Part 2 - Explanatory Report

Anstey Park is located within the suburb of Secret Harbour. The structure plan is the overarching framework guiding the development of the residential estate known as Anstey Park.

The primary purpose of this amendment is to relocate the proposed public open space (POS) to be located in the northern Figure 1 - Anstey Park LSP Aerial Photograph portion of Lots 35 and 36 to the southern portion of Lot 35 and Lot 36 along Surf Drive. As a result of the relocation of POS, the R30 lots are also to be relocated to around the new location of the POS.

Figure 1 - Anstey Park LSP Aerial Photograph

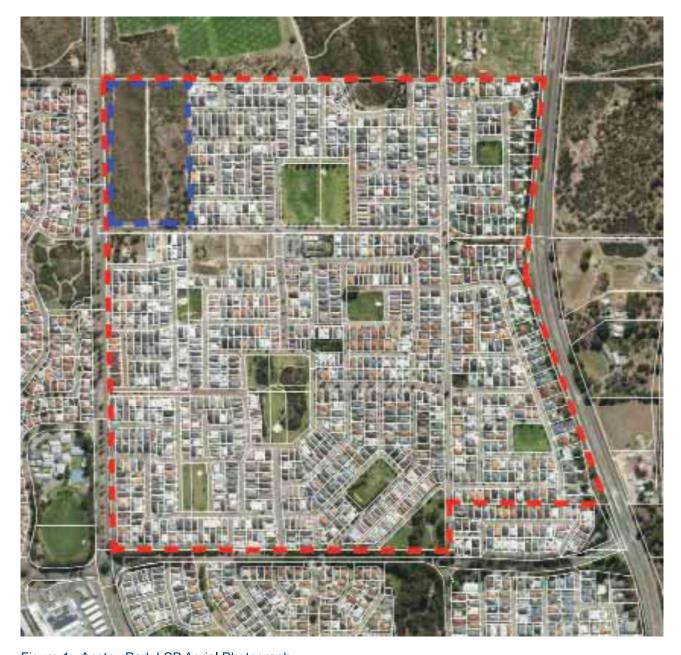
The LSP supports residential development which is now substantially completed with the exception of the lots the subject of this amendment (Lots 35 and 36 indicated in blue in Figure 1 below) and some smaller lots along Surf Drive (refer to Figure 1 below). The LSP provides for a range of densities from R5 to R40, an established local centre and established and planned areas of open space.

The relocation is required as the current location of the POS is on the highest point of the site which will require significant earthworks. The current location is not practical due to the required earthworks and a drainage network discharging into the stormwater basin contained within the POS. Amending the location will greatly reduce the volume of earthworks and tie-into the area with the surrounding road network.
